Project: TINEX - APPLICATION RC13924 **Memo:** 2/R0 **Page:** 1 of 24

Topic: Assessment of Landscape & Visual Effects and Landscape Management Plan – Review

Attention: Heather Perring – Western Bay of Plenty District Council

From: Dave Mansergh

Figure 2: Extent of Mitigation Planting Required for the Mitigation of Existing On-Site Activities (Boffa Miskell)

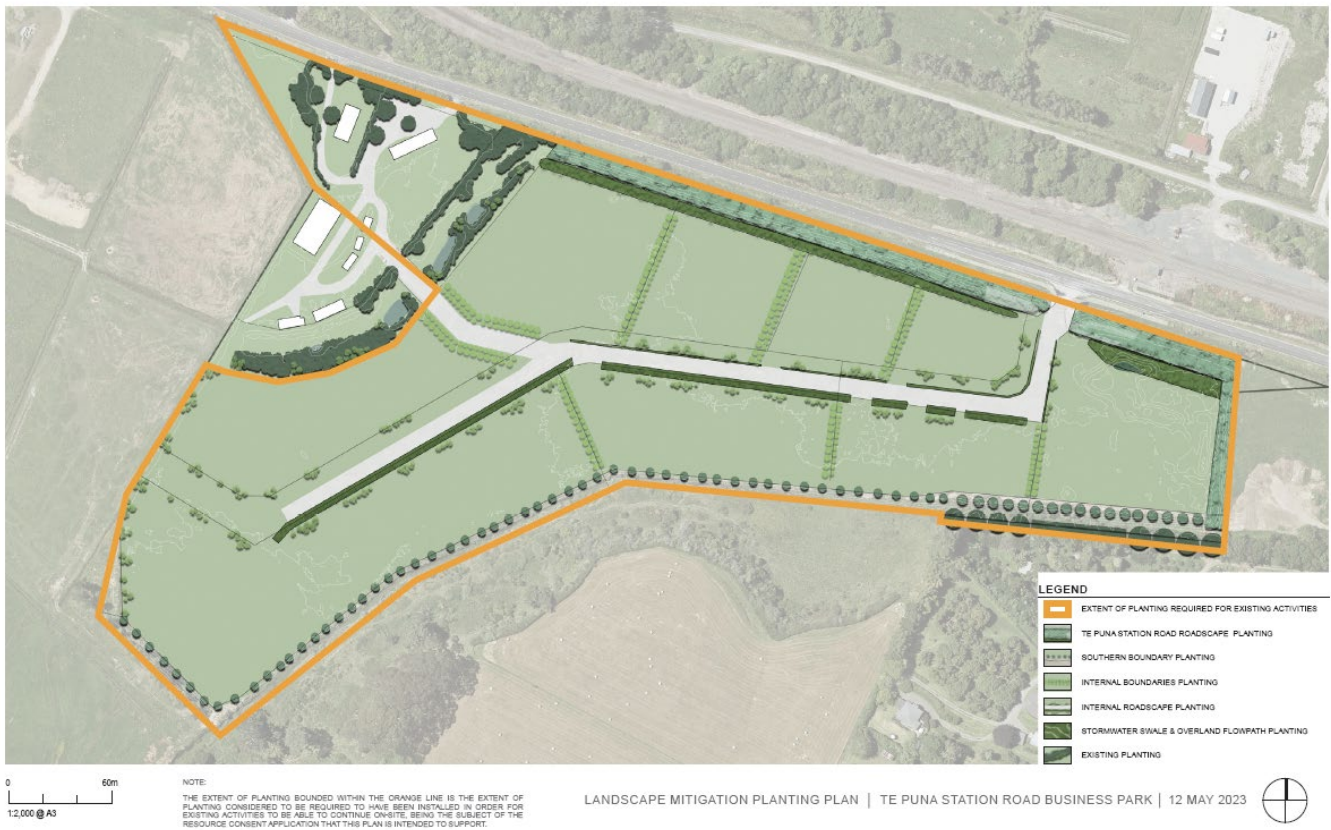
While the proposed landscape mitigation plan is generally consistent with the TPSP in terms of the general location of mitigation planting, differences exist in the configuration of the planting identified in the LMP and that shown in the TPSP.

The key difference, which is most likely to influence the effectiveness of the proposed mitigation (when compared to that required by the TPSP) is the configuration and depth of planting identified in the cross sections contained in *Section 7 – Structure Plans* of the ODP (Figure 2 below). The cross-section contained in the TPSP shows a planted depth of 10m is required around the perimeter boundary of the TPSP area. The LMP only shows planting to this depth along the northern (Te Puna Station Road) and eastern boundaries of the site. The depth of planting along the southern boundary is inconsistent with the requirements of the cross-section, where the LMP identifies a 50%/50% mix of *Pittosporum crassifolium* and *Pittosporum eugenioides* at 2.5m spacing along the boundary.

The LMP is not dimensioned and therefore does not meet the requirements of 4A.6.1.1.11.

- e. Landscape Mitigation Planting Concept Plans (Contained in the LMP) and the Landscape Mitigation Planting Plan Extent of Planting Required for The Mitigation of Existing On-Site Activities: These plans provide a high-level overview of the general type and location of the proposed mitigation planting. It is noted that the spacings shown on the plans often differ significantly from the spacing indicated in the related plant schedule.

- iii) Planting along the southern boundary of the site shall be a minimum width of 10m in accordance with the requirements of the Te Puna Business Park Structure Plan - Perimeter Planting Cross Section*
